### APPEAL SUMMARY

<b>Appeal ID:</b> 23399	<b>Project Address:</b> 4451 NE 42nd Ave
<b>Hearing Date:</b> 2/5/20	<b>Appellant Name:</b> Melissa Meiners
<b>Case No.:</b> B-003	<b>Appellant Phone:</b> 503 708-2157
<b>Appeal Type:</b> Building	<b>Plans Examiner/Inspector:</b> Steven Mortensen
<b>Project Type:</b> commercial	<b>Stories:</b> 3 <b>Occupancy:</b> R-2 <b>Construction Type:</b> V-B
<b>Building/Business Name:</b> Society 42	<b>Fire Sprinklers:</b> Yes - Throughout Building
<b>Appeal Involves:</b> Erection of a new structure	<b>LUR or Permit Application No.:</b> 19-247186-CO
<b>Plan Submitted Option:</b> pdf [File 1]	<b>Proposed use:</b> Apartments

SOCIETY 42

CODE ANALYSIS  
PLAN - LEVEL 1

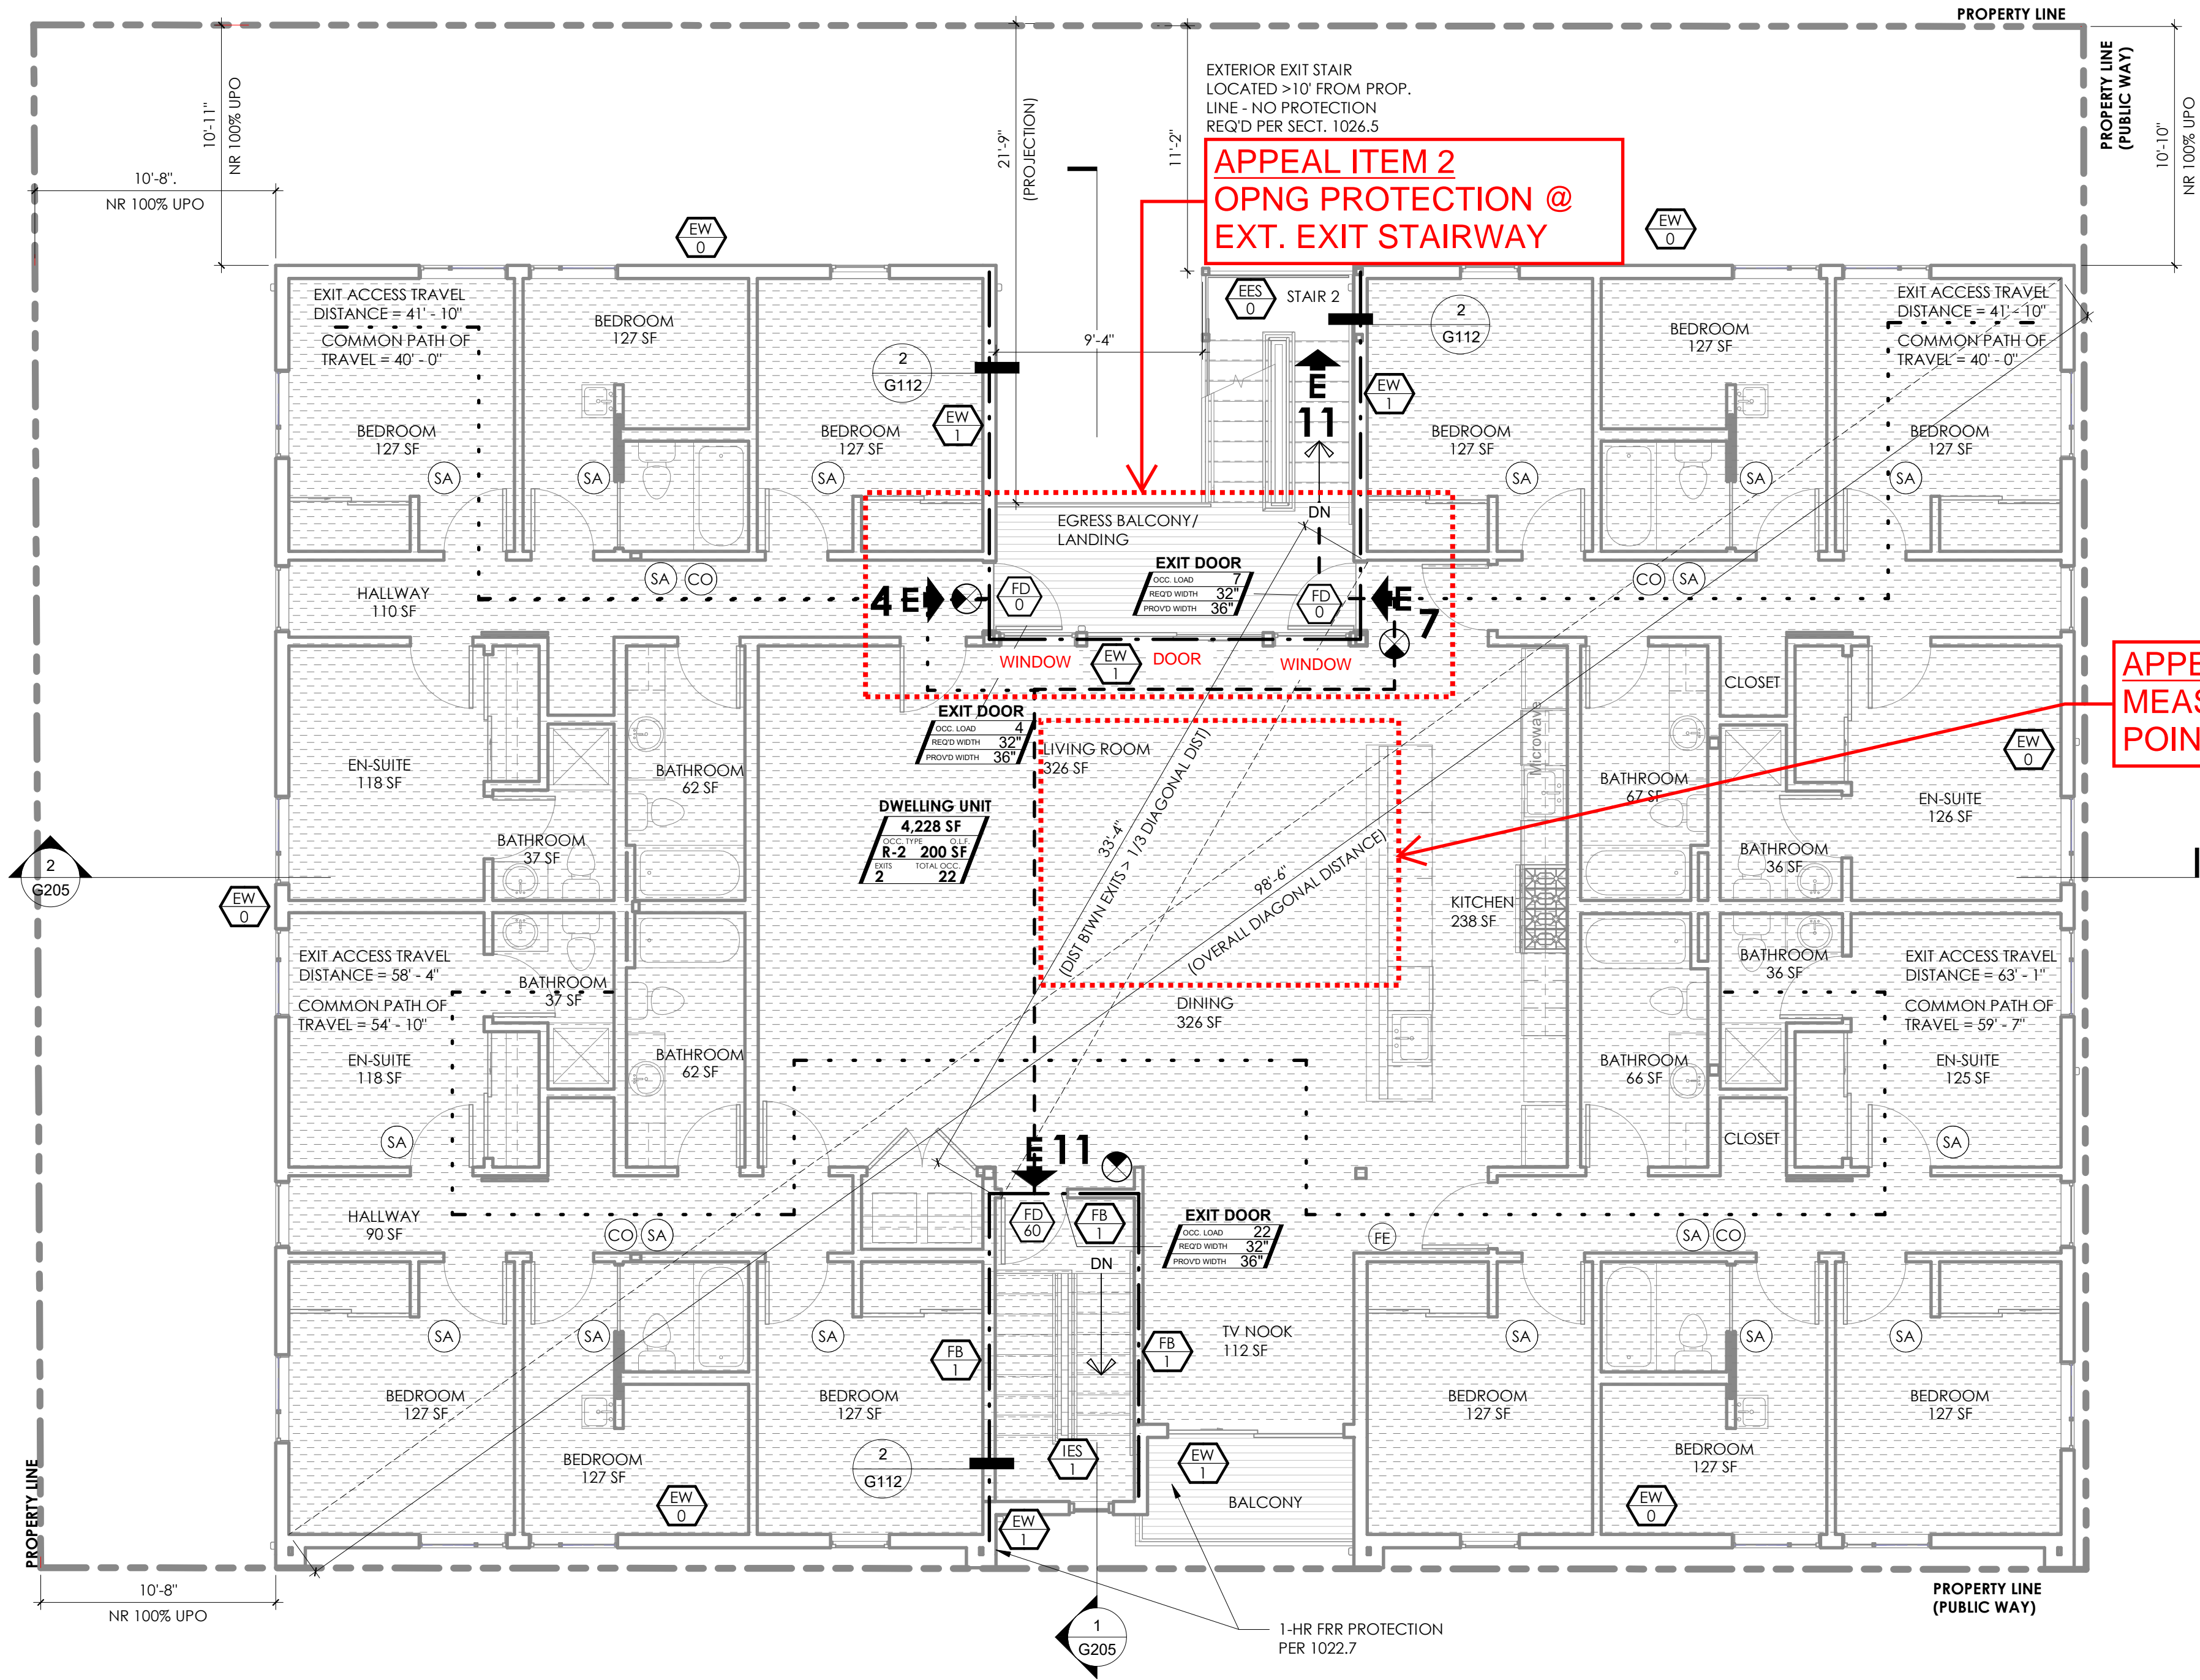
**Proposed Design** 2 exits are required from the second and third floors due to occupant load, per 1015.1 Excpn 1 and Table 1015.1.

2 exits are provided; 1 interior exit stairway and 1 exterior exit stairway.

The building is fully-sprinklered per NFPA 13.

The separation distance between exit doors are located not less than one-third the length of the diagonal dimension.

**Reason for alternative** The appeal is not intended to request an alternate to what the code requires, but to request to use provisions in the 2019 OSSC which define how travel distance shall be measured as it relates to exit doors, because the 2014 OSSC does not fully define this.

2019 OSSC Section 1007.1.1.1.1 Measurement Point permits "The separation distance to exit or exit access doorways shall be measured to any point along the width of the doorway."

The changes implemented in the 2019 OSSC provide clarification and allowances for how this measurement can be taken. Travel distance can be measured to the far edge of the exit or exit access doorways which implies up to the door jambs, and is not required to be measured to the centerline of the opening.

**1. Determination of exit separation distance per 2015 IBC: Granted as proposed.**
